Add to First Lutheran Church

CITY OF PORTLAND, MAINE
 DEVELOPMENT REVIEW APPLICATION
 PLANNING DEPARTMENT PROCESSING FORM

RE: First Lutheran Church - ID #20010012, CBL #374-A-13
Response to letter from J. Spence dated March 12, 2001

PLANNING BOARD REPORT #15-01

AT #4
TYPE "H"
70 W MA

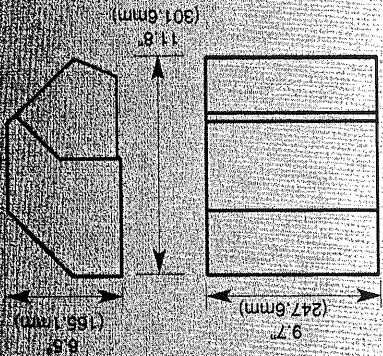
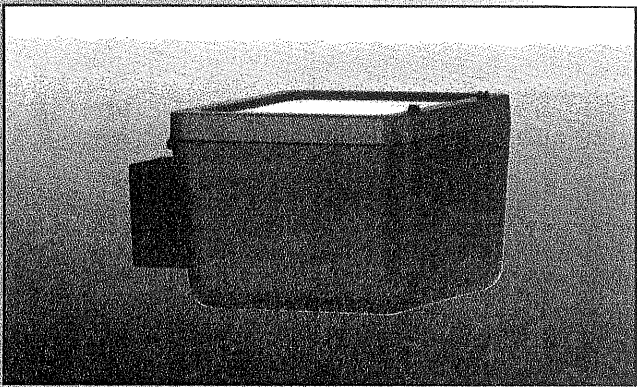
4. Catalogue cuts of the pole mounted light fixture and the wall pack fixtures must be submitted for staff's review. All fixtures must be cut-off fixtures. A lighting photometric plan for all three light fixtures must be submitted to determine that there is no spillover onto abutting properties. Also, what will be the height of the lights?

2. The proposed 25ft. pole light exceeds the maximum allowable height of 20ft. The photometric plan for this light does show some minor spillover onto an adjacent property. This spillover might be eliminated through a reduction in the height of this light. A revised photometric plan must be submitted in addition to a revised height for this light. With the addition of this light to the site, will the other pole light in the vicinity be able to be angled more towards the ground?

1. Delivered by messenger is a better copy of the wall-mounted fixture that I had selected for the Type H fixture. I checked with the distributor for this fixture, and he tells me that looking straight in, the lamp is not visible but that from the underside looking up, it is. He is sending me cuts as soon as he receives them for a substitute fixture which is much more expensive. However, the nearest house to the west is 340 ft. away. I have a hard time believing that the originally selected fixture will cause any light pollution to that house. Again, the nearest houses to the south are 130 ft. away and screened by thick evergreens and firs along the property line. Again, I question whether there will be any light pollution to those houses.
